RE: Submission on Amendment C296case Croskell (Employment) Precinct Structure Plan

Ethos Urban continues to act on behalf of Galileo Group (Galileo) who control the land holding at 585 Berwick Cranbourne Road (the site) within the Croskell (Employment) Precinct Structure Plan (PSP). The site is 53.58 hectares in area and has direct interface to both Berwick-Cranbourne Road and Thompsons Road. The site is identified as property 14 in the land budget of the Croskell PSP.

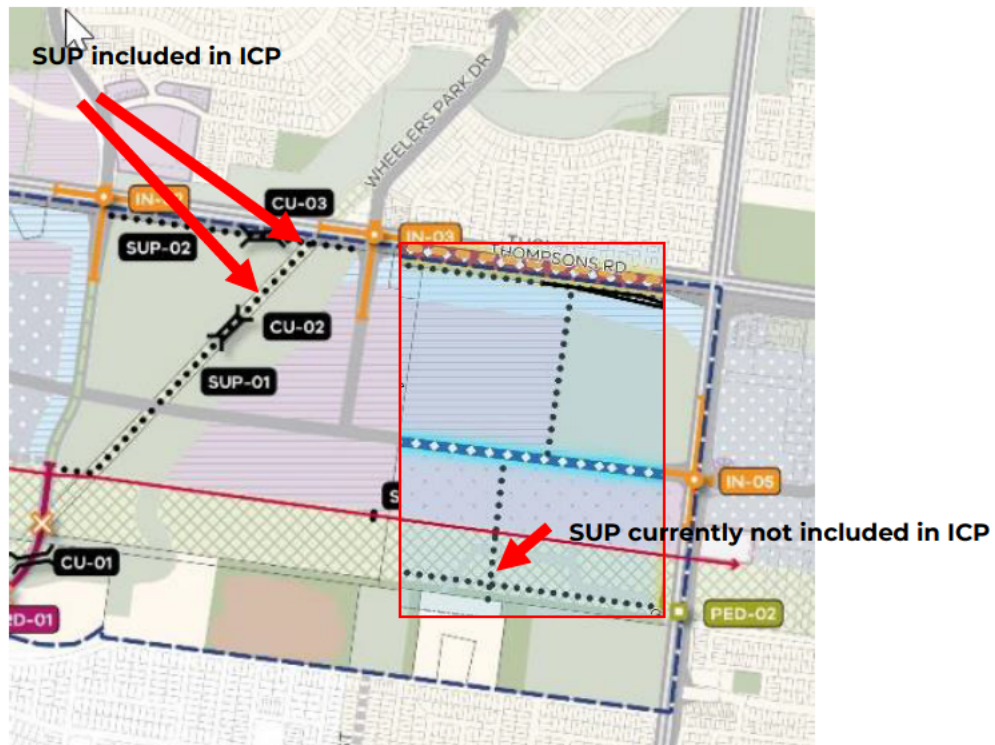
The VPA have in principle support from DEECA for the five crossings shown on the plan. These include a vehicle crossing at Casey Boulevard, four pedestrian crossings and one crossing for drainage infrastructure. While a high level design has been provided for these crossings the final design still needs final approval from DEECA. One of Shared User Path (SUP) crossings is located in the Galileo land and is included in the ICP.

We note that the culvert crossing required in the Galileo site by the current Melbourne Water drainage scheme is not included as one of these crossings. Whilst the drainage scheme will be altered prior to the approval of the PSP any culvert crossing in the Galileo site that is required should be acknowledged as such in the PSP.

We submit that the SUP crossing in the Galileo land should also provide the potential for vehicular access to remainder of the transmission easement. The implication of not providing this as a vehicular crossing point with the potential for vehicular access is that the land is made inaccessible and unable to be accessed in future, thereby orphaning the land and reducing the capacity of the land to be used for efficient purposes. We will be seeking further legal advice in relation to the isolation and severance of this land, particularly given that the land to the south is also being acquired for open space.

Feature Survey, south-east corner of site, showing existing access to Berwick-Cranbourne Road: KLM Consulting, 2024

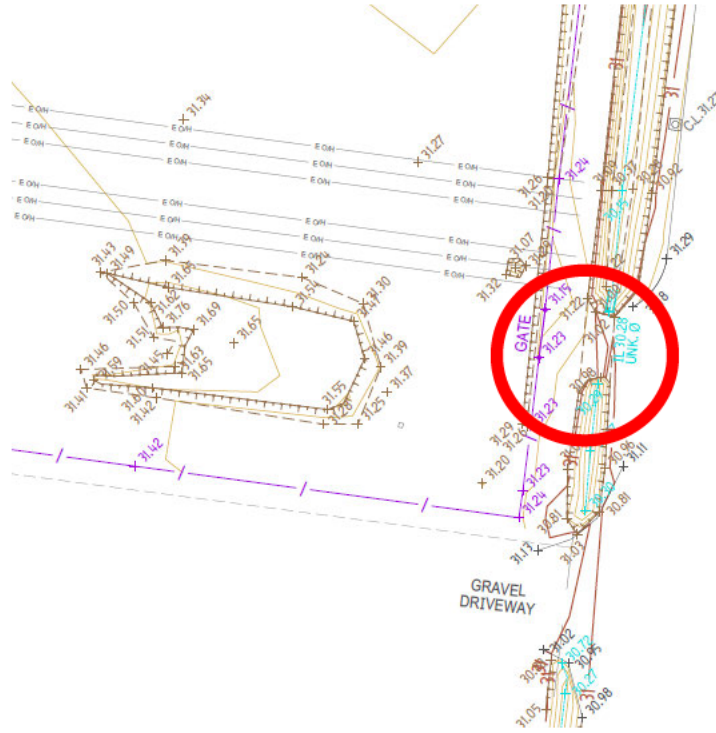
In light of the above, it is essential that the current access point from Berwick-Cranbourne Road is maintained and we request that this access point is shown as a left in-left out . This is shown in the plan below.

We request that the left-in left out is acknowledged on Plan 4 – Movement Network and public transport plan in the PSP. We submit that a left in-left out treatment north of the proposed pedestrian signals is superior the current location south of the signals, as this will work better with access and egress.

Proposed intersection and road access to Galileo site overlaid on Plan 4 - Movement network and public transport plan

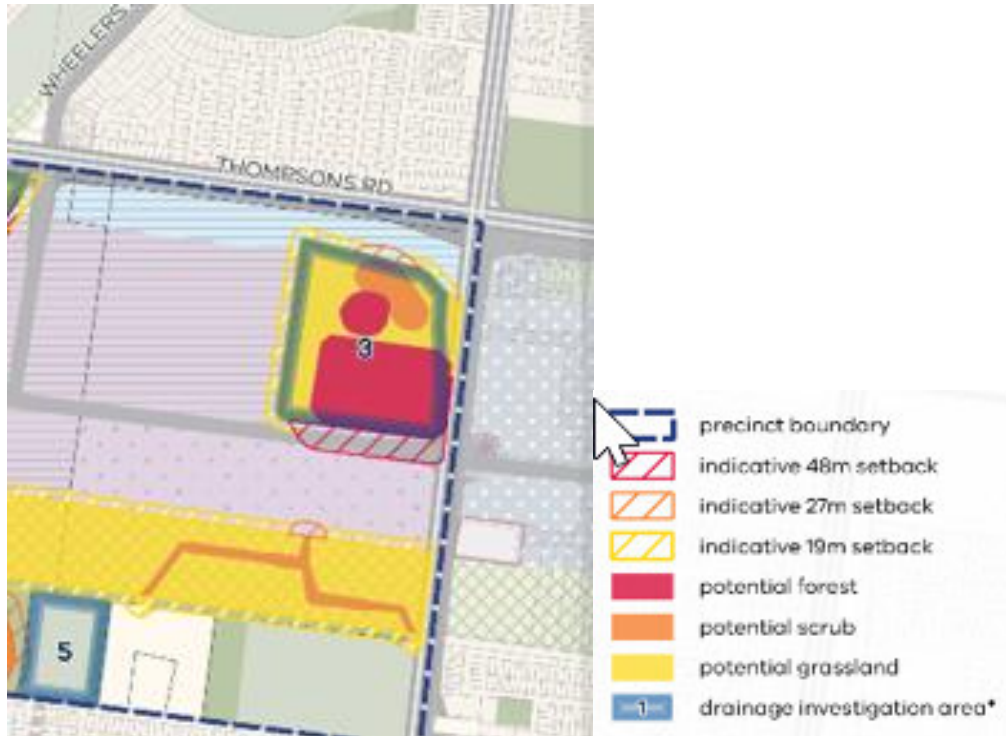
Further to the above discussion, direct access to the open space should be provided from the current access to the transmission easement. This will ensure that when the open space is acquired that access to the transmission easement is preserved. This should be identified on Plan 4 – Movement network and public transport plan as shown below.
